**PREPARED TESTIMONY OF RICHARD KUPREWICZ  
EVALUATING PG&E'S PIPELINE SAFETY ENHANCEMENT  
PLAN**

**CALIFORNIA PUBLIC UTILITIES COMMISSION  
PIPELINE SAFETY RULEMAKING  
R. 11-02-019**

**Submitted on behalf of  
THE UTILITY REFORM NETWORK (TURN)**

January 31, 2012

**Figure 1: Number of Miles Scheduled for Strength Testing by PG&E's Decision Step Output**

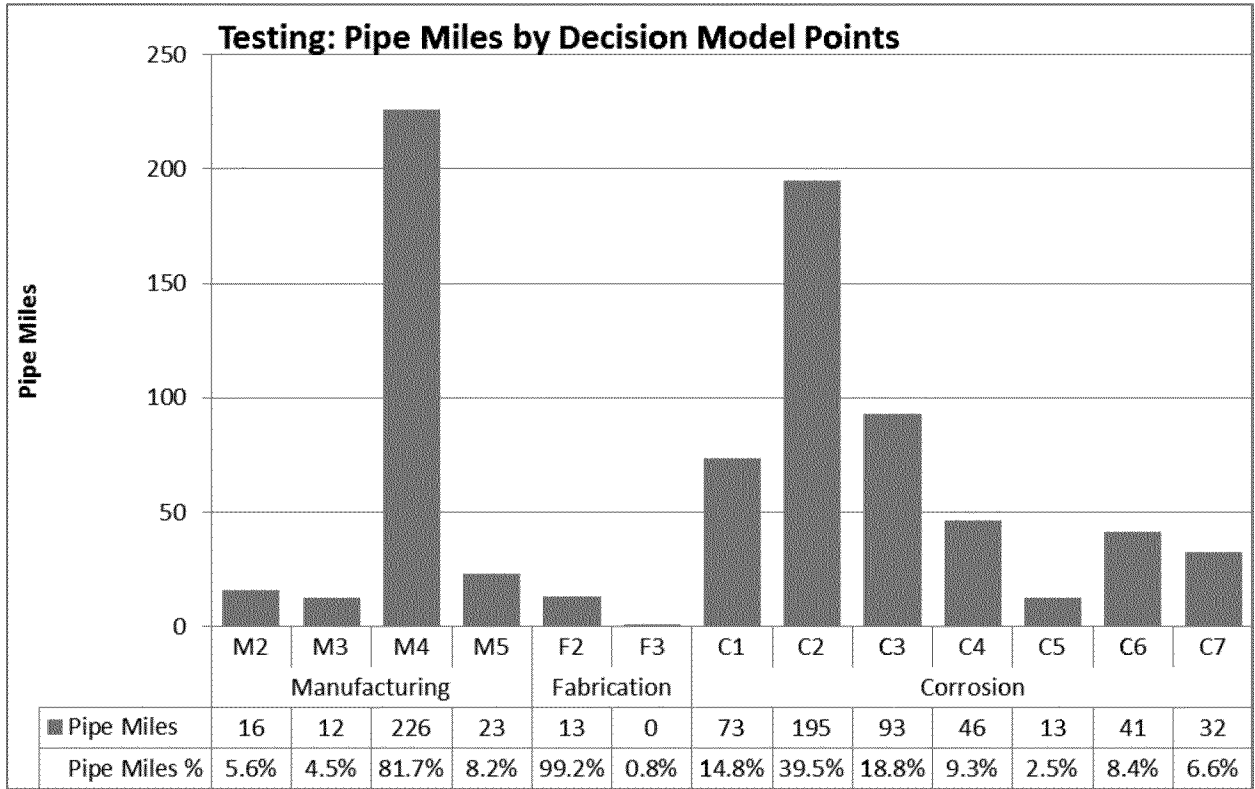
**Even more specifically, PG&E’s scope of work can be defined by the specific “action” boxes in PG&E’s proposed decision trees which dictate the nature of Phase 1 work, as illustrated in Figure 1 and**

- Corrosions Threats: The Decision Tree needs to be revised. For the 493 miles PG&E is proposing to be scheduled for testing due to the corrosion decision tree (see Figure 1), I recommend that ILI is a better assessment tool if the pipe can be retrofit for piggability. Prudent leak survey analysis, however, will be a better assessment approach for the lower stress (< 30 SMYS) segments where corrosion/third party damage is the only threat of concern. I do not recommend relying on any of PG&E's past integrity management outcomes.

**Figure 2: Number of Miles Scheduled for Replacement by PG&E's Decision Step Output**

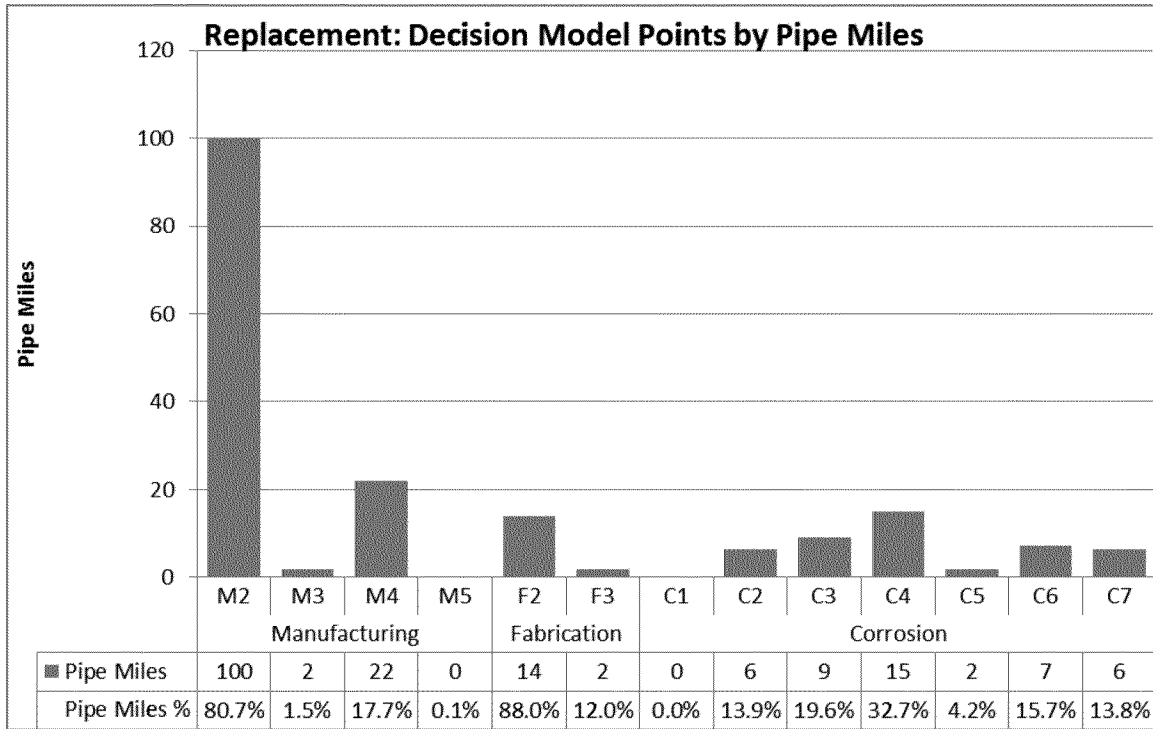
For example, over 100 miles of replacement result from PG&E's Decision Tree Step M2. Step M2 results in a decision to replace large diameter (during Phase 1) Urban pipe with manufacturing threats that operate at >30% SMYS. Step M2 should be modified to say, "Reduce Pressure & either Strength Test or Replace in Phase 1." If the line can survive a prudent hydrotest the extreme of replacement for seam weld threats needs to be specifically justified. Before proceeding to a replacement decision other steps should be added asking or indicating what critical factor(s) drive to replacement over hydrotesting or ILI? For example does the pipeline segment contain at -risk manufacturing seam factors that hydrotesting or ILI cannot adequately assess? And more importantly is there a problem with the pipeline segment that has led PG&E to determine that a specific pipe segment would experience numerous hydrotest failures that would justify pipe replacement? Could the pipeline be rationally shutdown for hydrotesting or ILI conversion? (if not, then pipe replacement may be warranted).

TURN believes the majority of pipeline meeting step M2 should be able to be hydrotested. Step M2 in PG&E's plan results in 100 miles of pipe replacement. I estimate that a very high percentage of this pipe, on the order of 95 +%, or 95 plus miles, would pass a prudent hydrotest and should not be replaced.

### **Figure 3: TURN’s Proposed Flow Diagram Replacing Steps 2F, 2G, F2 & F3 in PG&E Pipeline Modernization Decision Tree**

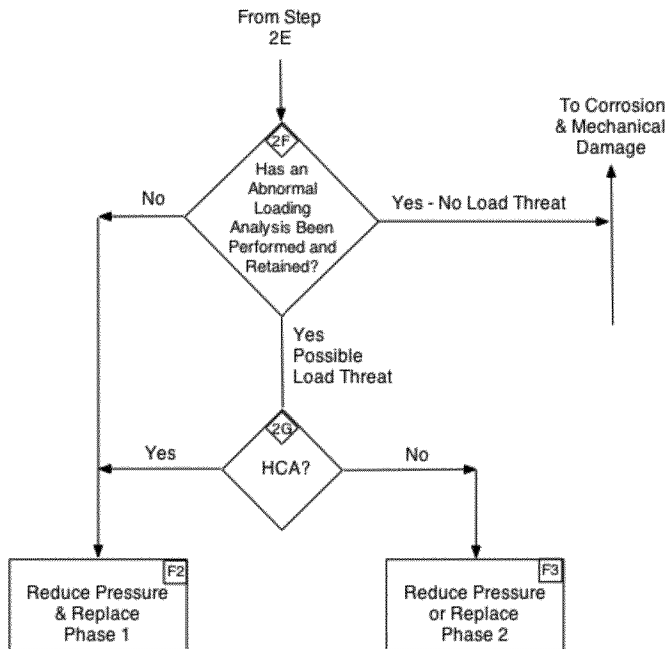
The Decision Tree Step 2F overstates the value of a hydrotest to the specific threats identified in 2E. Accordingly, 2F, 2G, F2 and F3 need to be reconfigured as hydrotesting is not the appropriate assessment tool for the threat categories identified in 2E. Hydrotesting is not the most effective assessment tool to test girth welds and other connections because of the lower hoop stresses.

TURN proposes that steps 2F, 2G, F2 and F3 be replaced as indicated in Figure 3. This alternate decision tree introduces another step to determine whether an “abnormal loading analysis” has been performed. Segments where the abnormal loading analysis has shown that there are no load threats can pass the Fabrication and Construction Threats tree, but should be added to a list of segments that PG&E should periodically monitor in their right-of-way program to assure the abnormal loading threat conditions haven’t changed.

**Figure 4: TURN's Proposed Decision Tree for Corrosion and Mechanical Latent Damage**

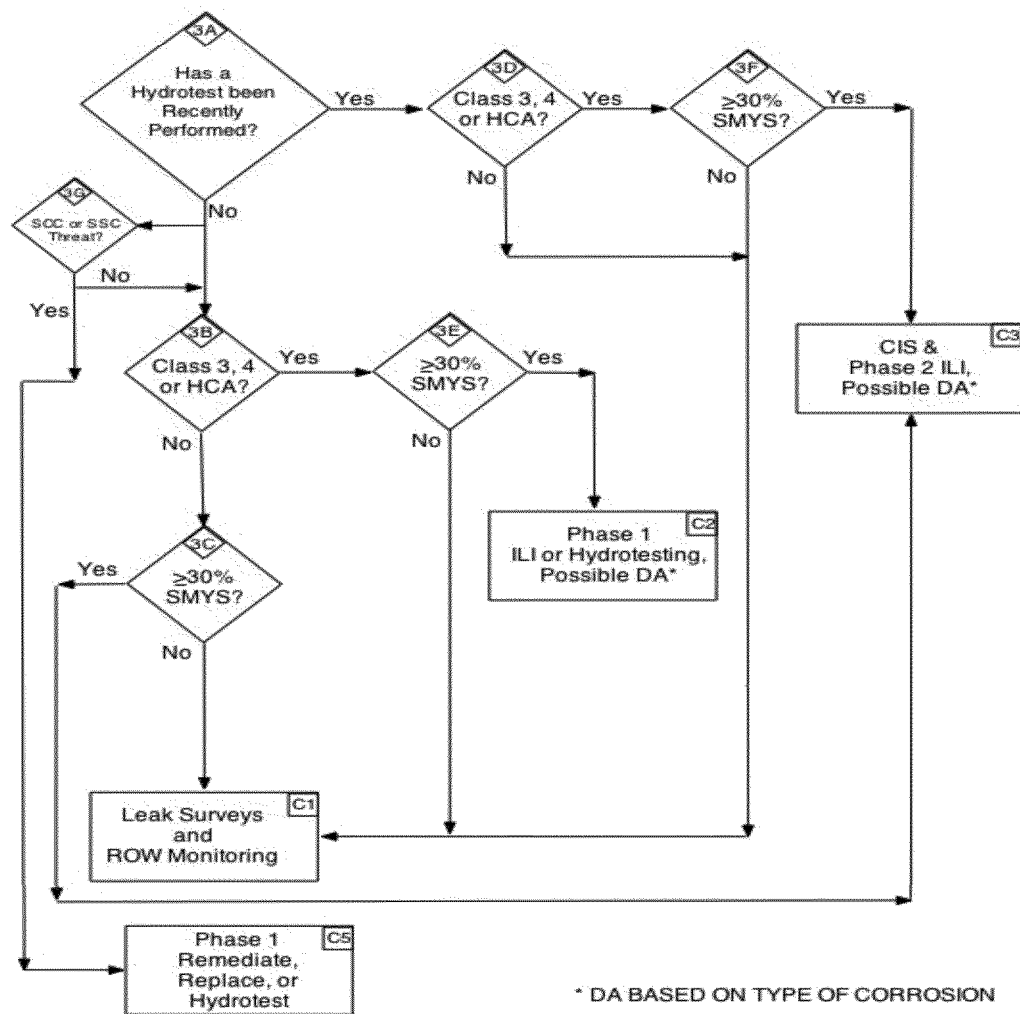
Given the nature of this threat family to cause time dependent pipeline failure (either leak or rupture), a previous Subpart J strength test, especially performed some years in the past, has little benefit in filtering out these risks of failure because a prudent hydrotest's intent is to take an existing at-risk anomaly to failure. PG&E's proposed Step 3A is thus incorrectly framed, as a hydrotest will not identify corrosion or mechanical damage threats introduced after the hydrotest. In addition, given the problems associated with PG&E's incomplete and inadequate integrity management program, we place little credit in its past program to address even the threats identified as "Corrosion & Latent Mechanical Damage Threats," and as a result TURN recommends not incorporating the BIAP step (step 3D) in PG&E's Decision Tree which is highly and overly dependent on DA (see Table 10).

In attachment 4, TURN has removed the Decision Tree Step 3D, as the reliance on improper and incomplete DA approaches or misapplication of DA in the past integrity management program, gives us little confidence that PG&E's BIAP has or is adequately addressing this threat category, even for corrosion threats. TURN proposes to change step 3D to a class 3 & 4 or HCA decision as shown in our revised decision tree.

Figure 4 is TURN's proposed flow diagram for this threat category that we believe is more appropriate and that should replace PG&E's PM Decision Tree for pipeline segments containing only this family of threats. Comparing Figure 4 to PG&E's Attachment 3A illustrates another problem when approaching pipeline threats utilizing a sequential flow diagram method. The conclusion may not make sense (such as suggesting hydrotesting or ILI for transmission pipelines that are much more likely to leak, rather than rupture), or might miss important threat considerations, such as Stress Corrosion Cracking, ("SCC"), or selective seam corrosion, ("SSC"), specialized forms of selective corrosion that usually

Figure 4. TURN is basically recommending for non urban areas, as well as urban areas both operating at < 30% SMYS step C1, that efforts be focused on leak monitoring/evaluation and prudent right-of way monitoring, unless these segments can cost effectively be converted to ILI over time.

Figure 5: Blowdown Time, reproduced from PG&E Figure 4-7

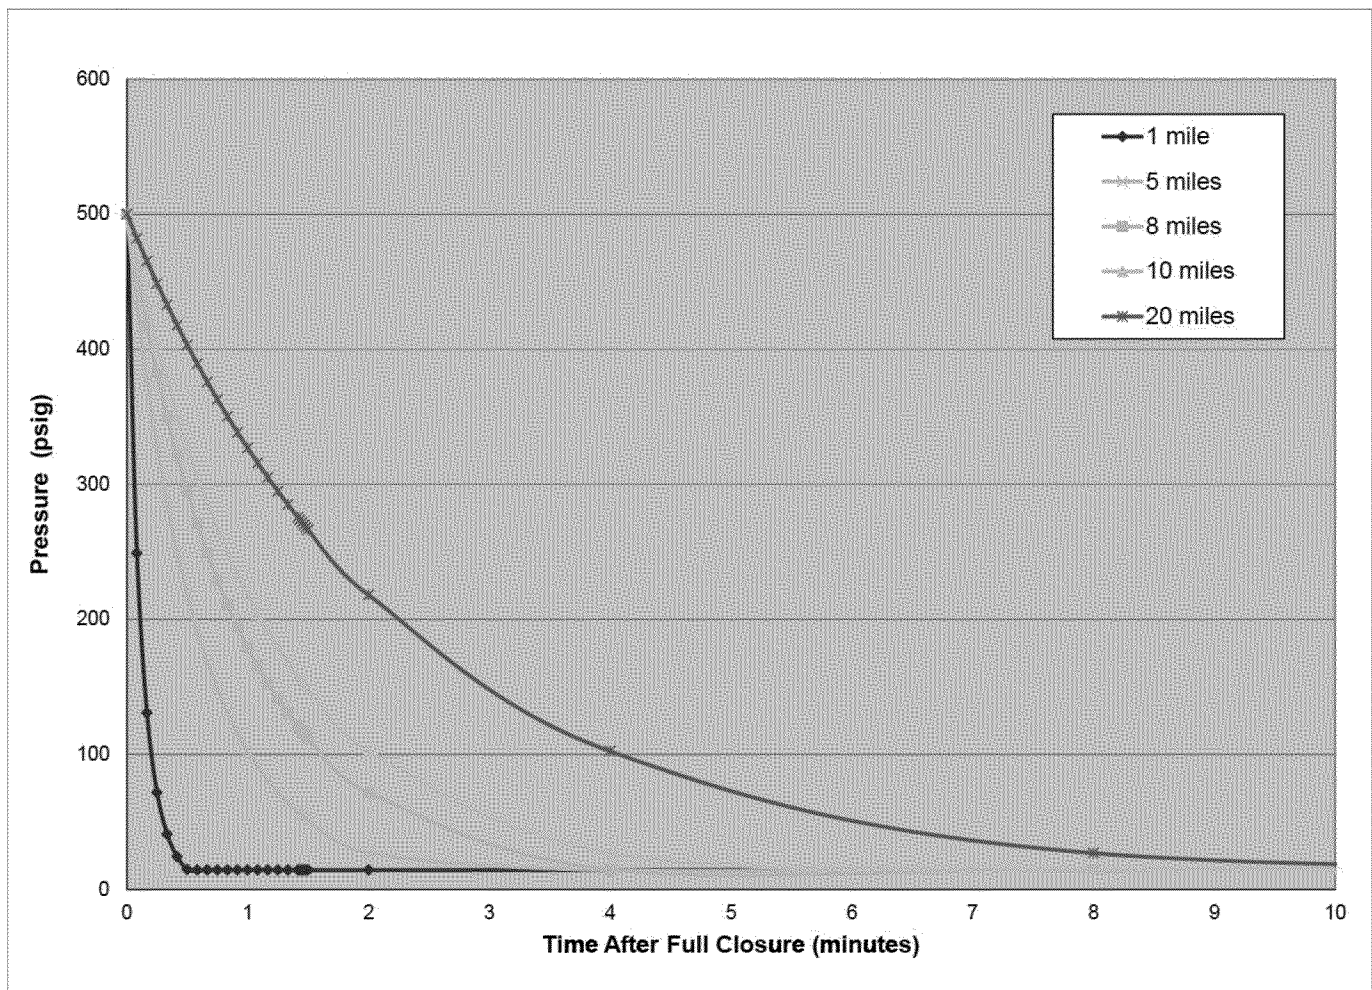
Figure 5 reproduces Figure 4-7 from PG&E'S Testimony. This figure is incomplete, as it is missing critical information, such as pipe diameter, and seriously understates the isolation blowdown release times for gas transmission pipelines following rupture. The figure attempts to identify blowdown times but fails to accurately portray such times for gas transmission pipeline ruptures.

PG&E apparently developed this figure for one particular pipeline diameter - a 12-inch pipe - and the calculation method used by PG&E's experts is unsuitable for long transmission pipelines.<sup>51</sup> The approach used by PG&E to estimate blowdown times for gas transmission pipelines ruptures to develop PG&E's Figure 4-7 is very inappropriate and should not be utilized for valve decisions on long gas transmission pipelines as pipe length, diameter, and friction factor play a substantial role in estimating rupture release impacts with time.

**Figure 7- Isolation Blowdown Time for Gas Transmission Pipeline Ruptures as a Function of Valve Distance from Rupture and Pipe Diameter**

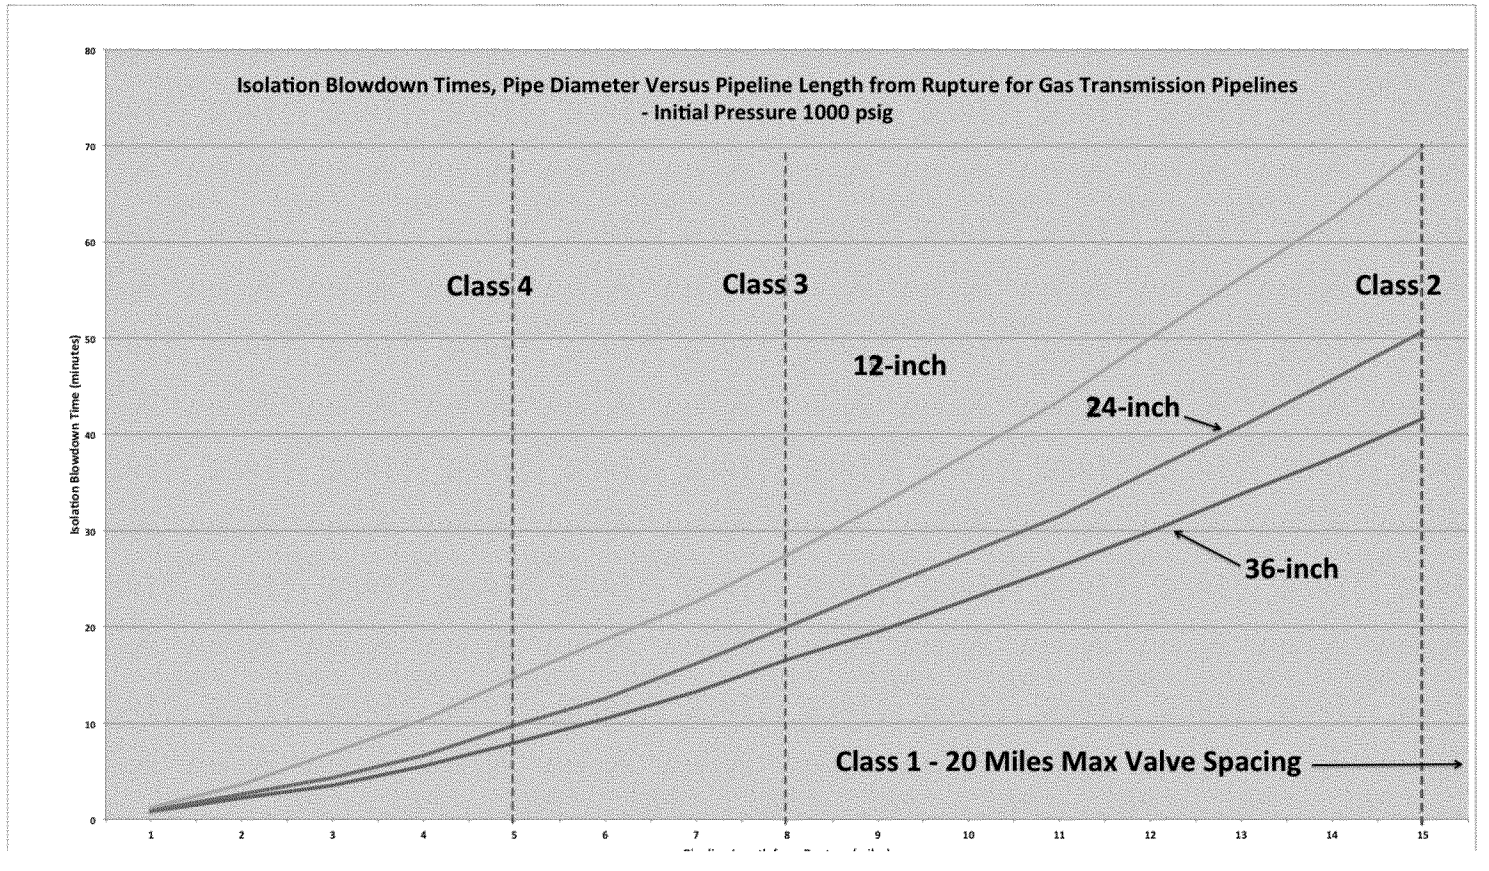
Figure 7 contradicts PG&E's testimony that "A full line break with eight mile spacing with a pipeline starting pressure of 1000 psig is estimated to blowdown in five minutes."<sup>56</sup> Figure 7 indicates blowdown times significantly greater than five minutes, regardless of the pipe diameter. PG&E needs to explain this serious discrepancy, and provide an appropriate engineering analysis representing transient compressible flow in transmission pipelines that can be independently publically reviewed and confirmed.

Figure 7 also indicates that for an 18-inch pipeline with a 7.2 valve spacing (see Figure 6), blowdown times for calculated vs actually measured time are comparable correcting for the higher initial pressure of 1000 vs 500 psig.

Figure 6 and Figure 7 indicate that valve spacing plays a much greater role in isolation blowdown times than indicated by PG&E's testimony. Isolation blowdown times clearly impact decisions related to valve spacing and valve automation.

Figure 9: PG&E Valve Decision Tree

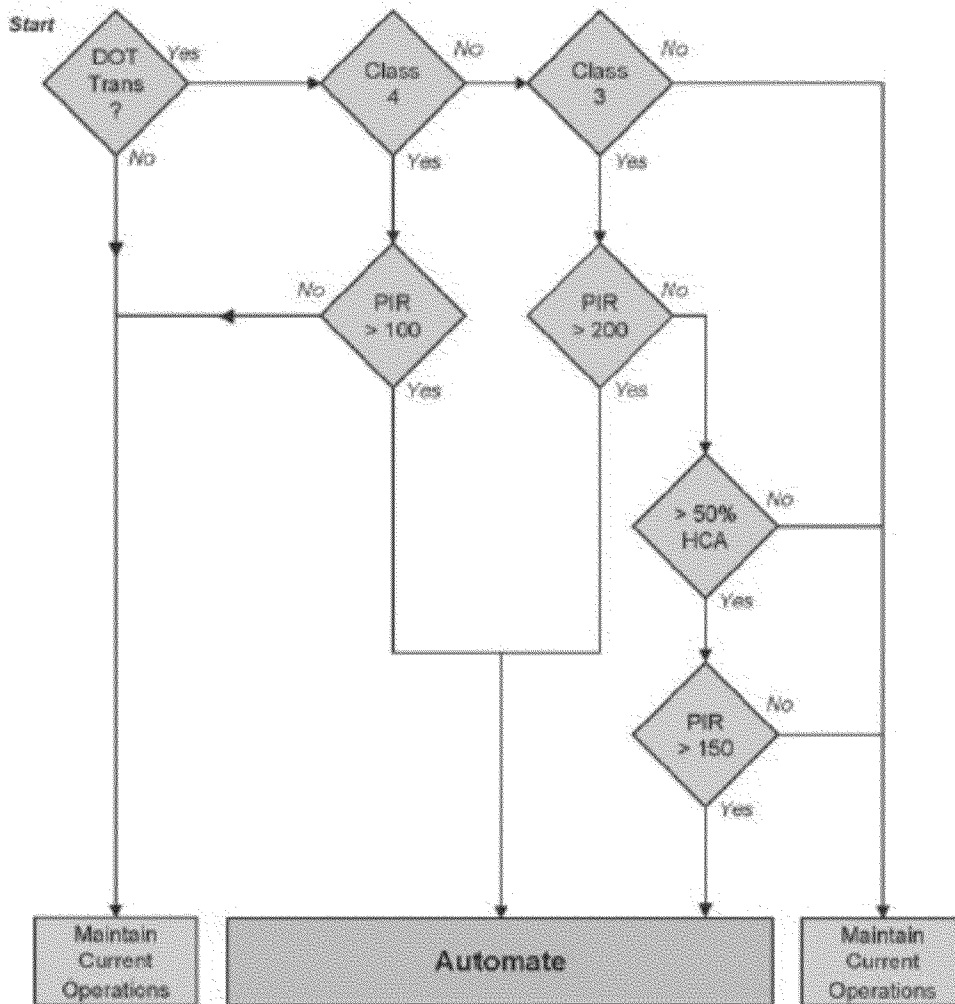
The PIR values identified in PG&E’s decision trees make little sense, especially with respect to the use of “low” PIR cutoff values (PIRs of 100, 150 and 200).<sup>63</sup> These low PIRs are reflective of very small diameter gas transmission pipelines, on the order of 12 to 16-inch, which will have very long duration isolation blowdown times. Additionally, PG&E statements trying to justify these low PIR values also reflect a very poor understanding of gas rupture release dynamics and proper emergency response for very high heat flux rupture events. For example, firefighters should never direct water streams into an ignited natural gas rupture roaring from a gas transmission pipeline rupture at 900+ mph as water is ineffective in such conditions. Well meaning first responder attempts to cool structures in close proximity to the rupture blowtorches or near very large gas clouds (See Photo 1, 2 & 4) can prove fatal. A first responder experienced with such very high heat intensities will understand that water will not protect nearby structures from such massively high heat intensity, or very turbulent gas clouds (see Photos 1, 2 and 3). The primary objective of emergency response to gas transmission pipeline ruptures is initially controlled by the pipeline operator and operators should quickly assure prudently spaced valves spanning the rupture are swiftly closed. Rapid closure of valves will knock down the higher rate heat release phase of the rupture as quickly as possible to allow first responders to safely enter the actual impact zone as soon as possible. As Figure 7 demonstrates, rapidly closing properly placed valves with spacing of no greater than 8 miles will substantially reduce the blowdown time on affected segments in the event of rupture.

PG&E’s decision trees, which are reproduced as Figure 9 and Figure 10 below, are inadequate.<sup>64</sup> PG&E’S use of the PIR in their valve decision trees does not adequately address the goal of quickly reducing high heat flux times and actual impact zones.

**Figure 12– PG&E’s Proposed Phase 1 Valves by Pipe Diameter and Pipe Miles in Class 3 and 4 and 4**

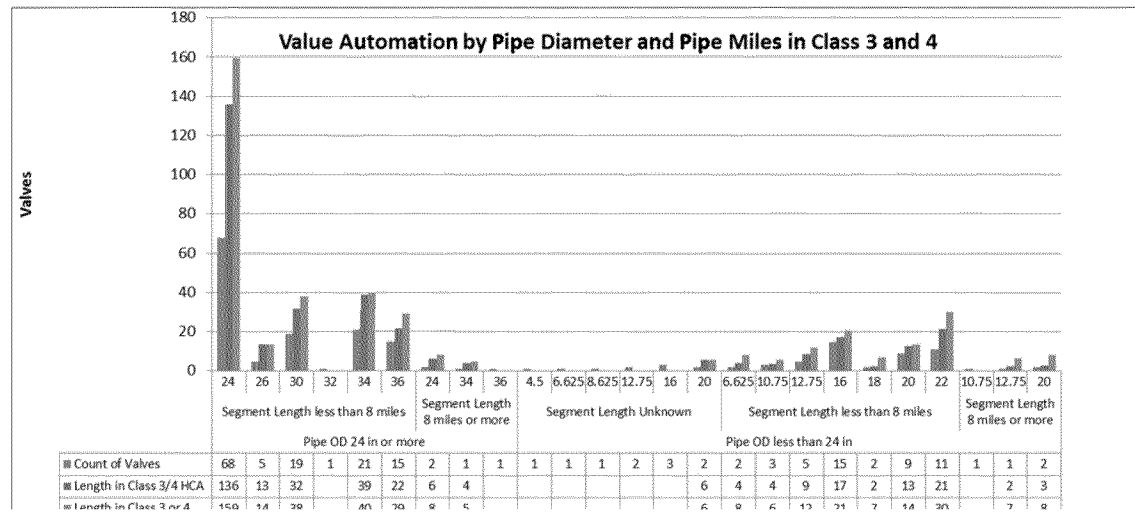
In addition Figure 12 provides a more detailed analysis of the PG&E proposed 194 valves in their proposed Phase 1. Figure 12 indicates that 61, or approximately one-third of PG&E's proposed valves, would be on lines less than 24 inch in diameter.<sup>66</sup>

Figure 12 also indicates that four of the Phase 1 proposed valves on the larger diameter pipelines have valve spacing greater than 8 miles. TURN believes a closer study of the specific location of these four valves is warranted, though the isolation blowdown may not change significantly. A review of Figure 7 indicates that isolation blowdown times for smaller diameter lines will prevent even ASVs from meeting the 30 minute responder goal for valve spacing of eight miles. Fortunately, smaller diameter pipelines produce much smaller potential impact zones following a rupture than their larger diameter counterparts during longer duration burns.
